RE: PacifiCorp/Rocky Mountain Power
Energy Gateway South 500kV Transmission Project
Revised Standard Form 299 Right-of-Way Application

**Revised Standard Form 299 Right-of-Way Application
Attachment A**

**Revised from
January 2013
Submittal**

Revised Standard Form 299 Right-of-Way Application Attachment B – Project Description

Figure 1 – Alternative Routes Map

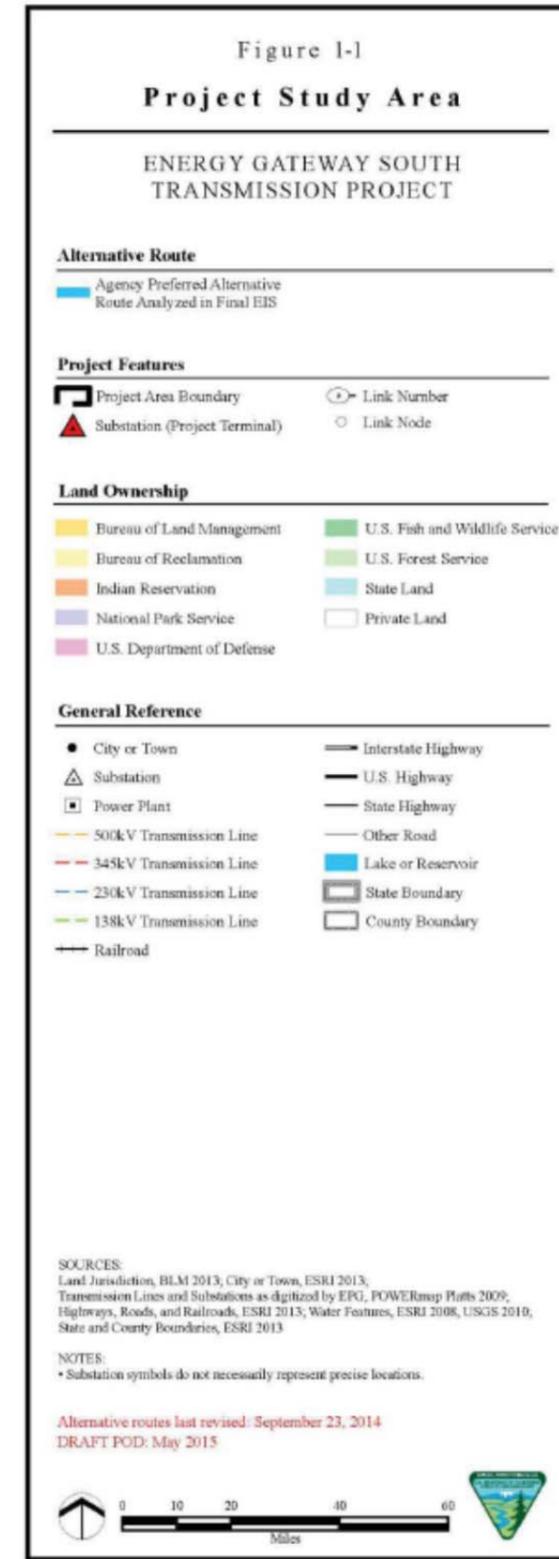
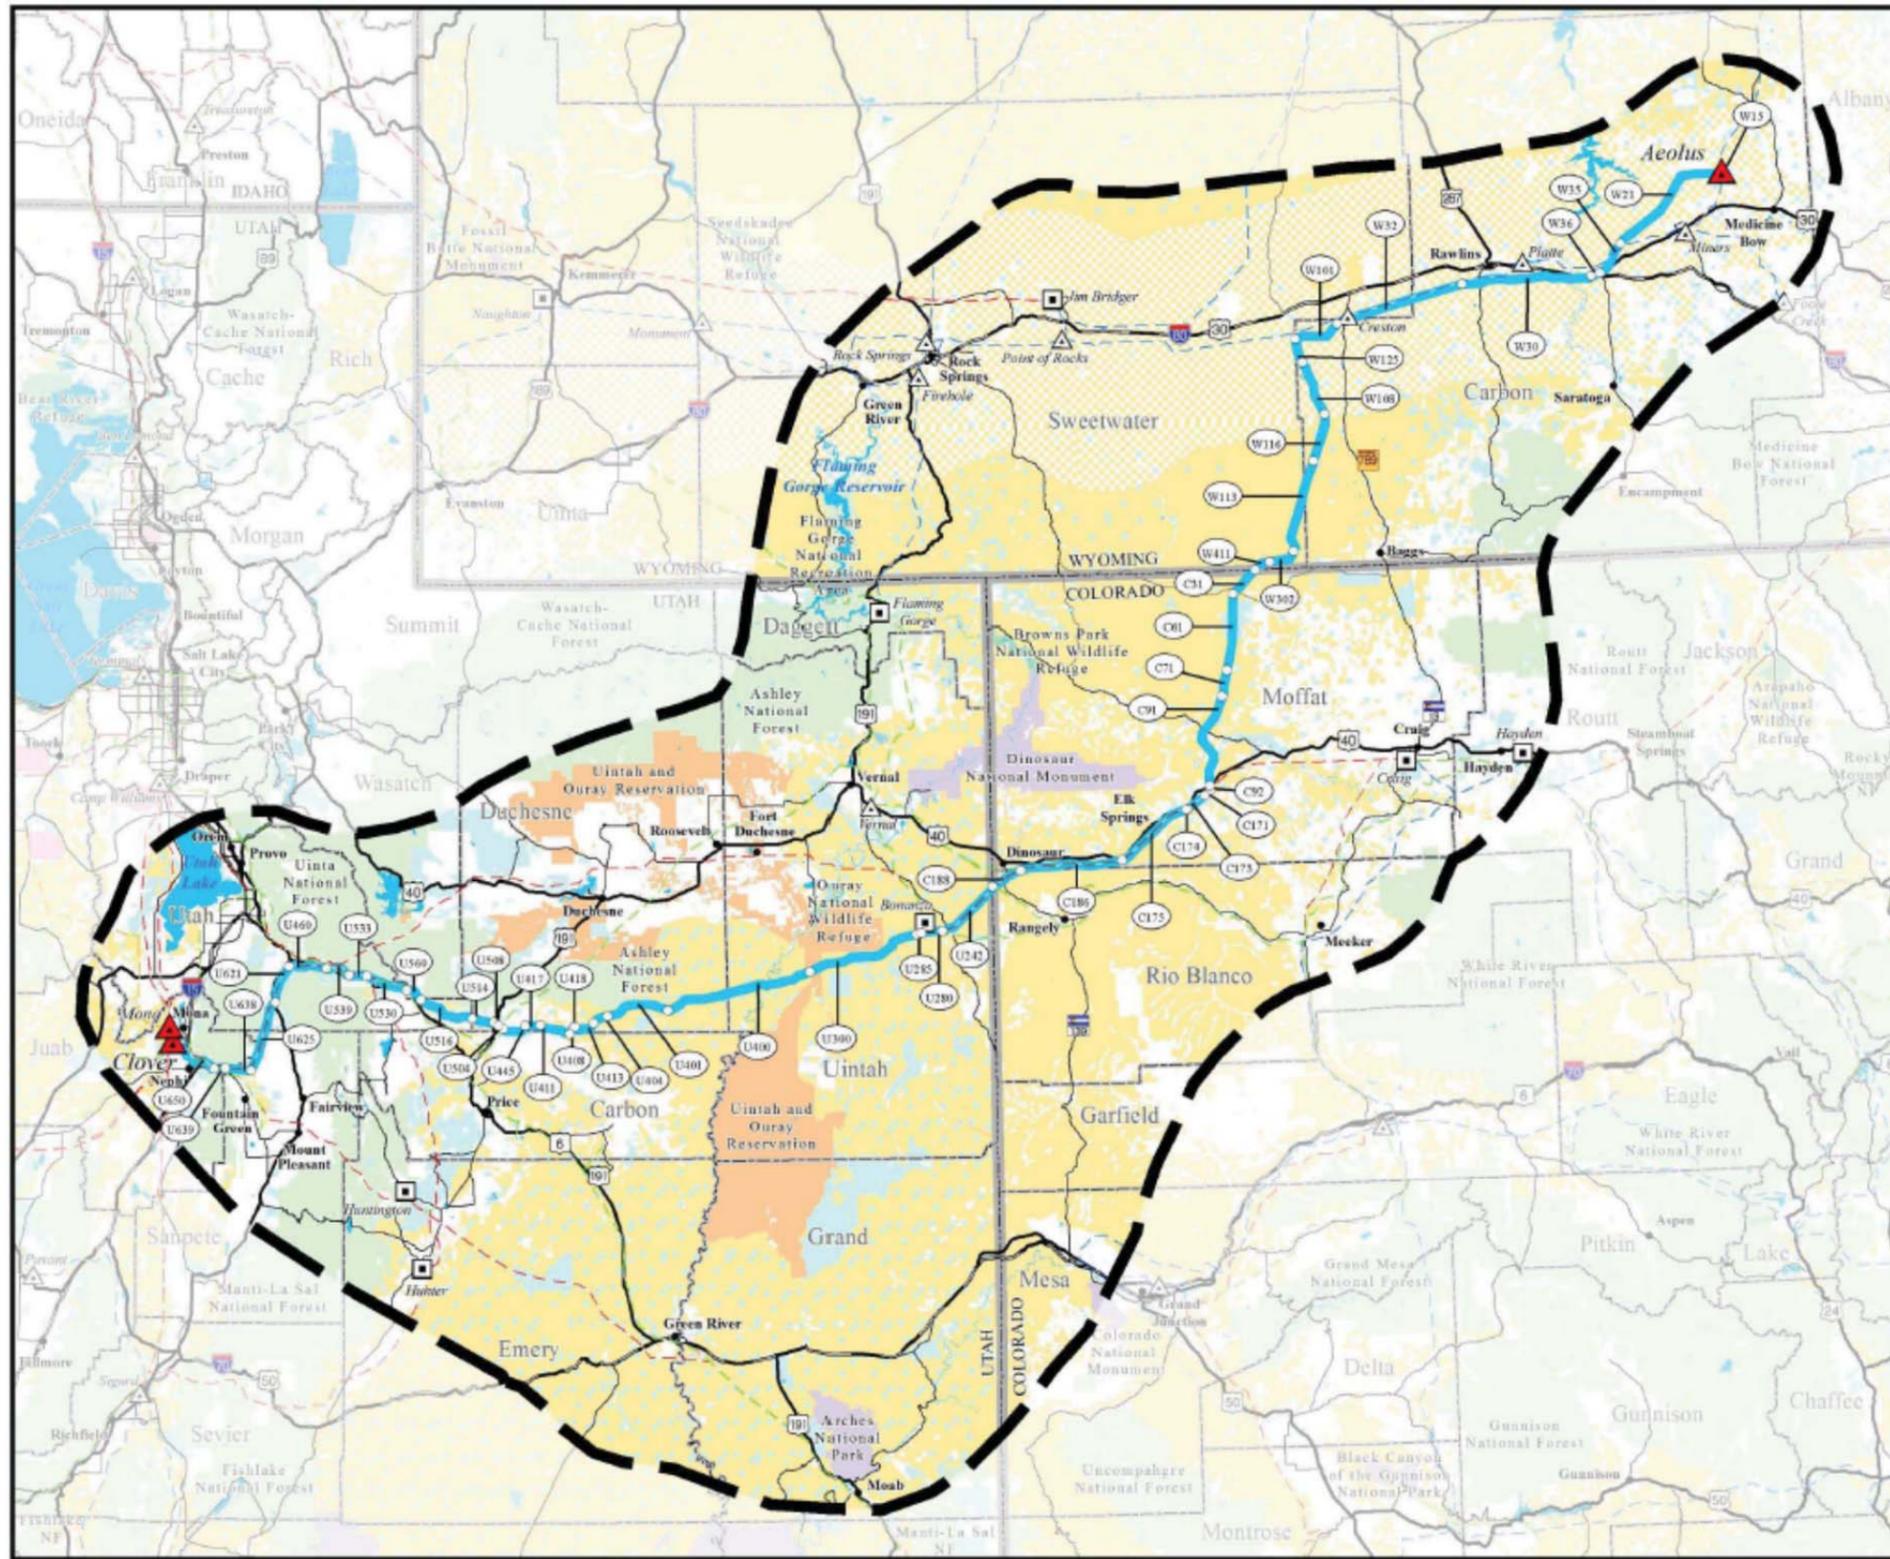
- Proponent's preferred route has been updated to relocate a small portion of the route outside the Raven Ridge ACEC
- Updated description of Project structures and facilities, such as the proposed use of guyed structures
- Updated physical specifications

Figure 4 – Proposed Guyed Delta Lattice Steel

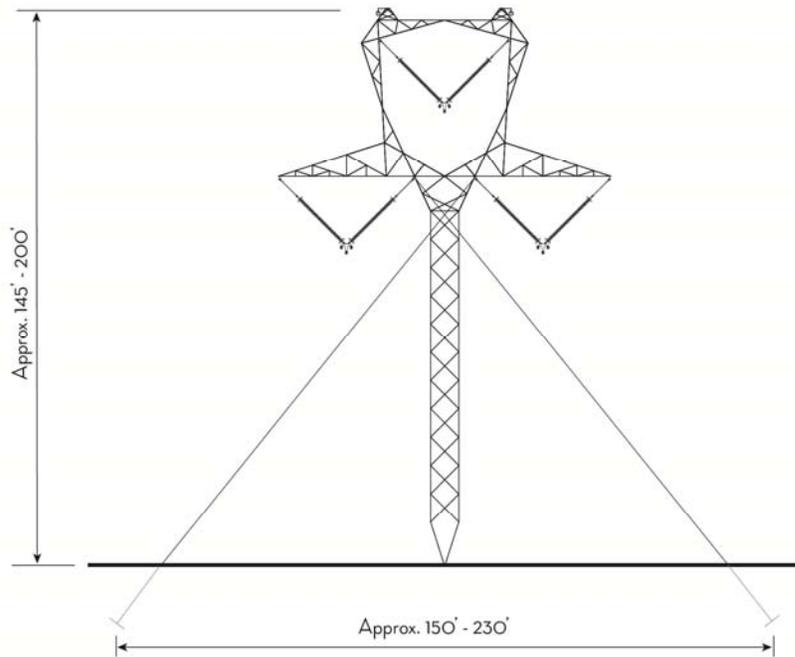
In general, single-circuit guyed lattice steel structures would be used in Wyoming, Colorado, and portions of Utah as tangent towers (in locations that have a line angle equal to or less than 1 degree) in flat to rolling terrain. In areas where terrain is rougher and in locations that have a line angle equal to or less than 1 degree, tangent towers would be self-supporting lattice steel structures. Self-supporting lattice steel towers would be used in all areas of the project where angles in the line would be greater than 1 degree.
